June 5, 2023

**Re: Response to Request for Additional Information for PDX109 Data Center BAER Assessment**

**Figure 1-2. Data Center Topology**

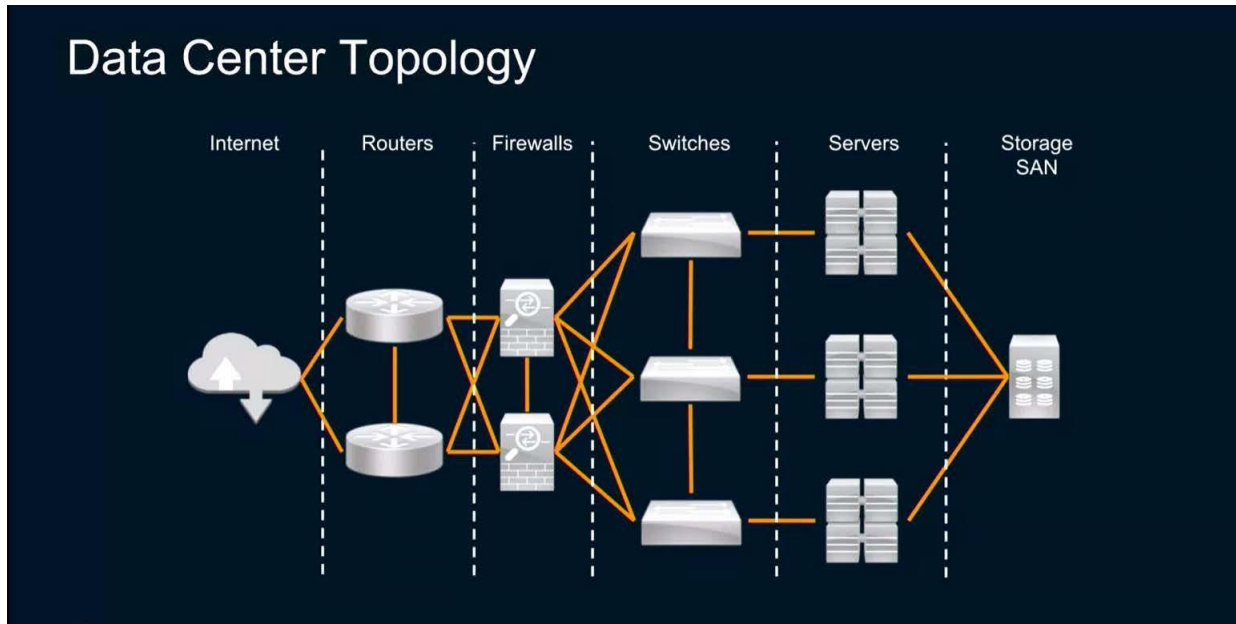
4. *An assessment must include “A description of the covered stationary source’s production processes and a flow chart of each process” [OAR 340-271-0310(2)].*
  - a. *Provide a list of the categories of electrical loads on site, separating out heating, ventilation and air conditioning (HVAC) loads from power used by servers and any other significant load types.*
  - b. *For each category, list the percent of the total site electrical load it consumes.*
  - c. *Provide data for the total electrical load at the site, showing fluctuations over the course of a day on the hottest and coldest days of a year, as well as average daily loads over the course of a year.*

Section 1 in the BAER Assessment has been revised to include a description of data center processes. We also added a graphic that provides an overview of Data Center topology.

SHEET TITLE: OVERALL SITE PLAN  
DRAWING NUMBER: G1.1

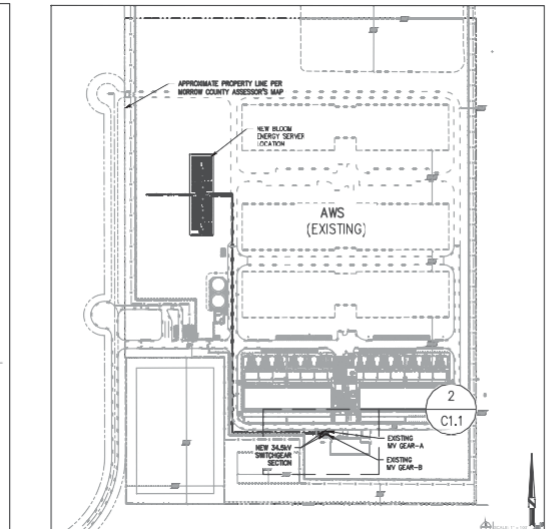
5. *Include a site plan showing the PDX 109 site, including site boundaries.*

We have added the requested site plan to the revised BAER Assessment.
